**Staff Report
Design Review and Variance
Peterson’s 76 Fueling Station
Prepared February 22, 2018**

FILE NUMBER: L17-0055 (Design Review), L18-0009 (Variance)

PROJECT NUMBER: PL17-0048

LOCATION: 13310 Interurban Ave S

Image 5: Proposed Lighting Styles

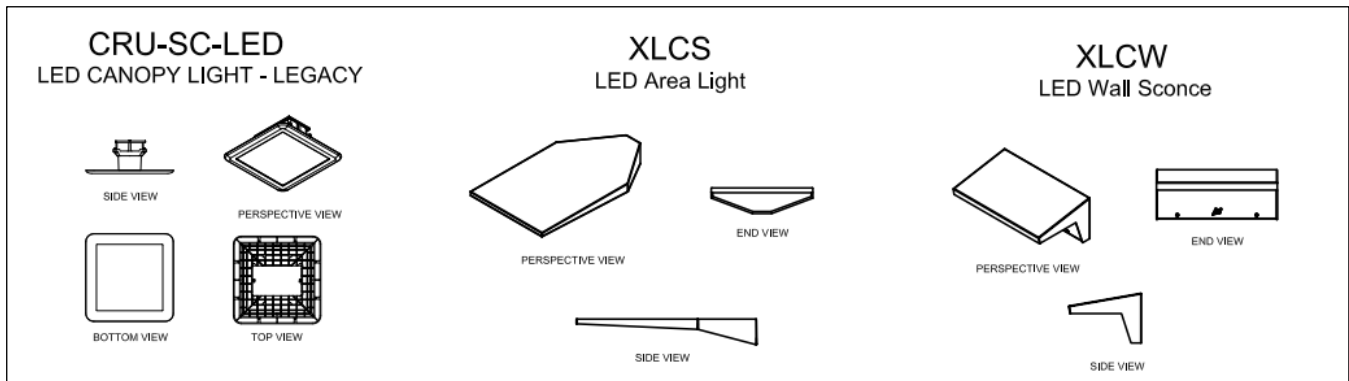
Lighting will be configured to provide safe vehicular and pedestrian travel through the site. 28 LED lights, ranging in strength from 3,806 lumens to 18,056 lumens, will provide adequate lighting through the parking lot and around pedestrian areas leading into the building. Lights will be shielded down to reduce impact to surrounding properties, and building mounted lights facing northeast toward the Days Inn hotel will be lower strength to reduce offsite impacts.

Site lighting will consist of light poles and new exterior lighting attached to building. Exterior lighting will be LED lights with minimalist, trapezoidal shape that will be in harmony with the overall building design. Lights will be shielded downwards to reduce impact to surrounding properties.

Image 7: Proposed Coffee Kiosk

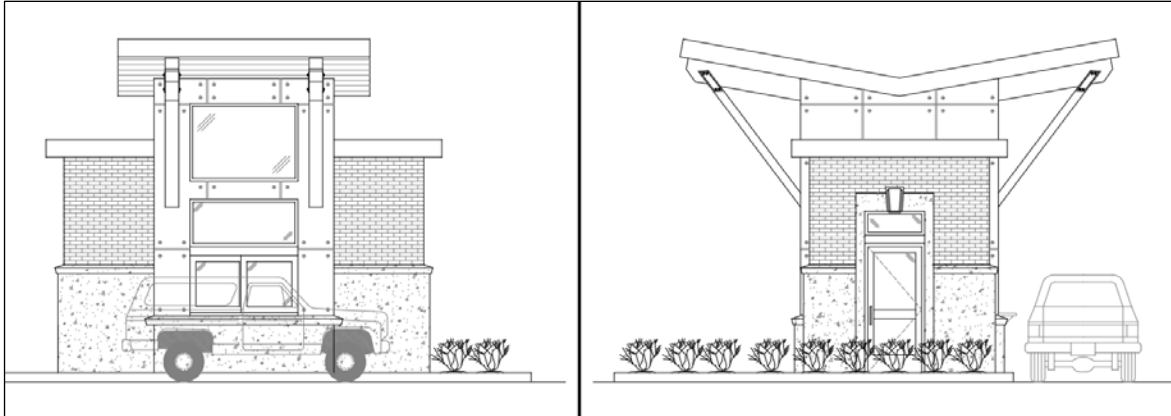
The convenience store and coffee kiosk have been designed to resemble one another, utilizing similar design elements, materials, and colors.

Pole lights on site will provide lighting for drive through coffee kiosk.
